**CITY OF MIDDLETOWN
PLANNING BOARD MEETING AGENDA
MARCH 5, 2025 7:00 PM
COMMON COUNCIL CHAMBERS
AND VIA DIGITAL TOWN HALL**

Re: **Mixed Use Site Plan for 68-70 Fulton Street (Promenade) Tax Grid No. 40-2-14.12**

We are resubmitting to the Planning Board for the Promenade at Middletown, 68-70 Fulton Street. The following is a response to the comment letter from Christian T. Moore, P.E. dated 12/13/2024.

Drawing Number:
2

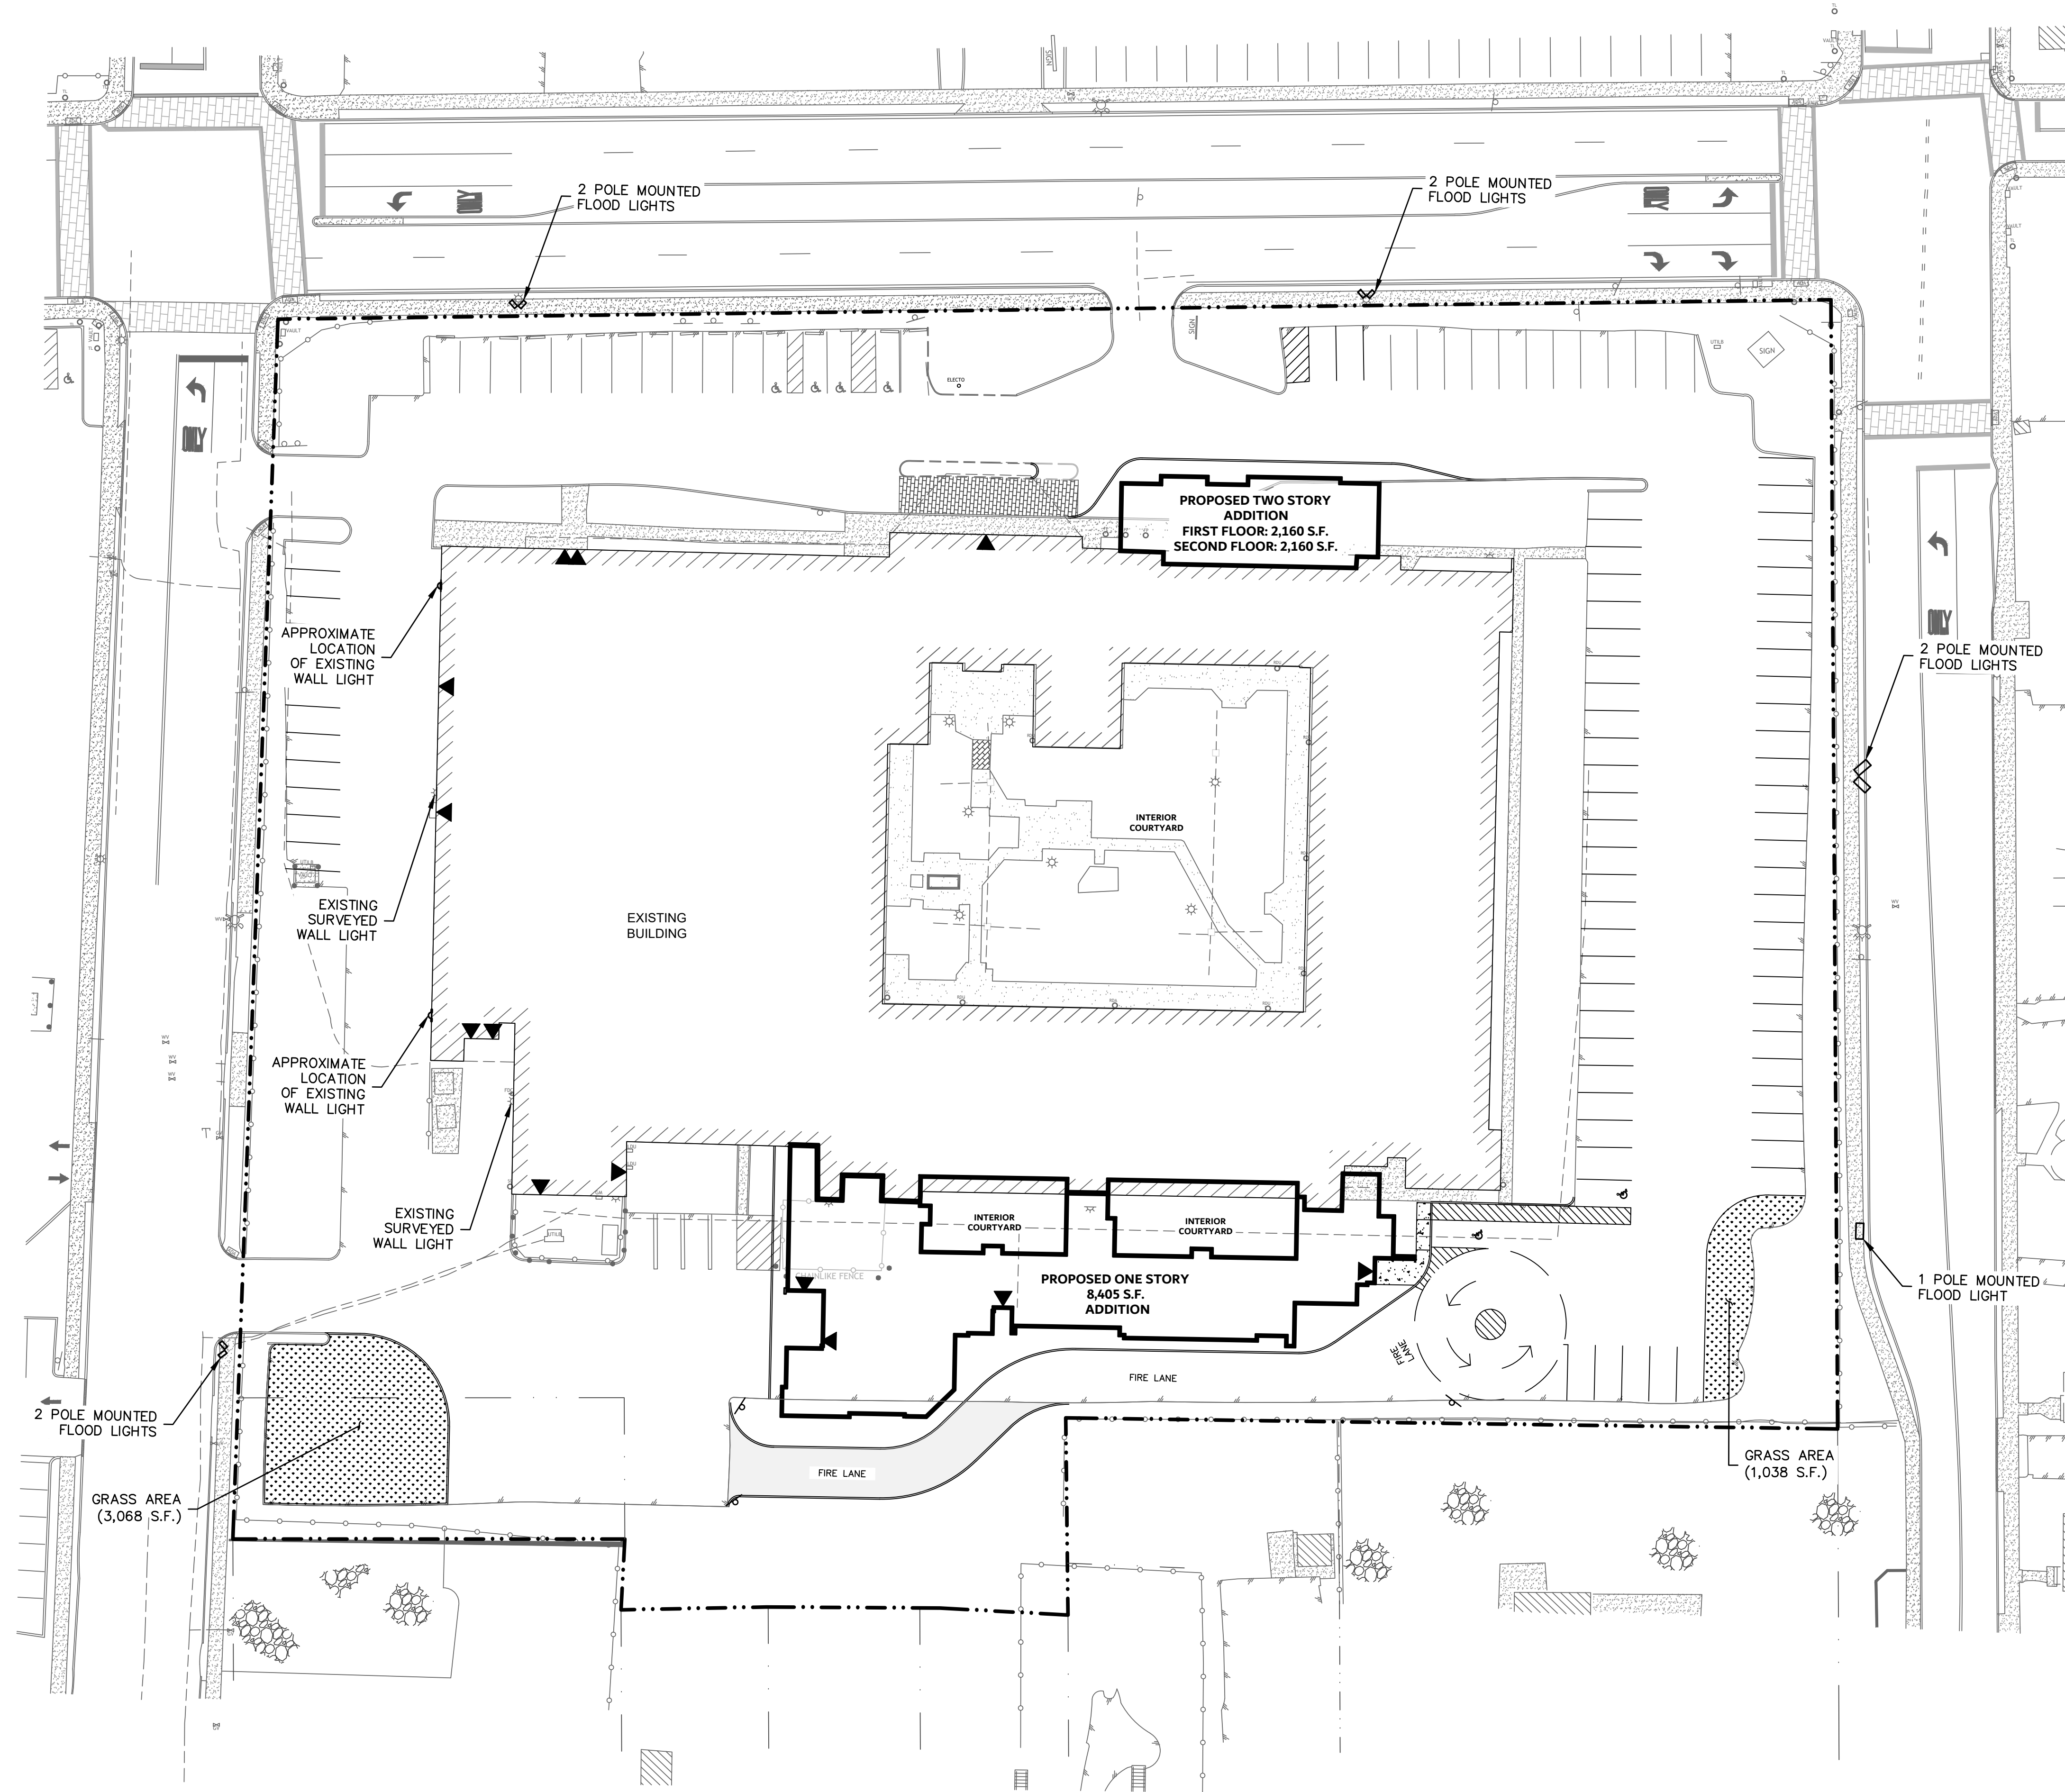
- 3) *Parking requirement calculations should be verified; there appear to be far more spaces than is necessary. Has there been a change in use of this site?*

The parking count shown remains unchanged and is an existing condition of the site. There has been no change in use to the site.
